Access Compliance Report

Public Rights-of-Way

(Pedestrian Signals)

Intersection ID: N/A	Main Street:	Cross Street: N/A	Location: N/A
ADA ID: BE6349353546	Signal Type: One Push Button-APS	Overall Compliance: No	Severity Score: BTN 1: N/A BTN 2: N/A No BTN: N/A
Codes/Mitigation Info/Possible Solution		Field Measurements/Component Compliance

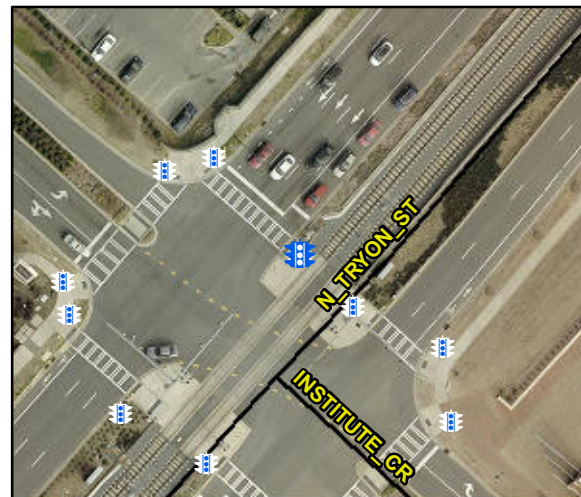
PROW/ADA: R404.3, R404.2, R404.7.3,
R404.7.2,

N/A	B 1 FWD Approach Width (in)	N/A	N/A	B 2 FWD Approach Width (in)	N/A
N/A	B 1 FWD Approach Obstruction?	Yes	N/A	B 2 FWD Approach Obstruction?	N/A
N/A	B 1 FWD Approach Obstruction Dist (in)	5.0	N/A	B 2 FWD Approach ObstructionDist (in)	N/A
N/A	B 1 PARA Approach?	Yes	N/A	B 2 PARA Approach?	N/A
N/A	B 1 PARA Approach Constrained?	Yes	N/A	B 2 PARA Approach Constrained?	N/A
No	B 1 PARA Approach Reach (in)	16.0	N/A	B 2 PARA Approach Reach (in)	N/A
No	B 1 PARA Approach Width (in)	48.0	N/A	B 2 PARA Approach Width (in)	N/A
N/A	B 1 PARA Approach Obstruction?	Yes	N/A	B 2 PARA Approach Obstruction?	N/A
N/A	B 1 PARA Approach Obstruction Dist (in)	6.0	N/A	B 2 PARA Approach ObstructionDist (in)	N/A
Yes	B 1 Clear Floor Space Slope (%)	1.4	N/A	B 2 Clear Floor Space Slope (%)	N/A
No	B 1 Clear Floor Space XSlope (%)	3.4	N/A	B 2 Clear Floor Space XSlope (%)	N/A
N/A	B 1 PAR Slope (%)	N/A	N/A	B 2 PAR Slope (%)	N/A
Yes	B 1 Height (in)	40.0	N/A	B 2 Height (in)	N/A

Possible Solutions: Remove & Replace
Replace APS Button With New APS Button.
Provide PAR As Indicated. Remove and
Replace Clear Space.
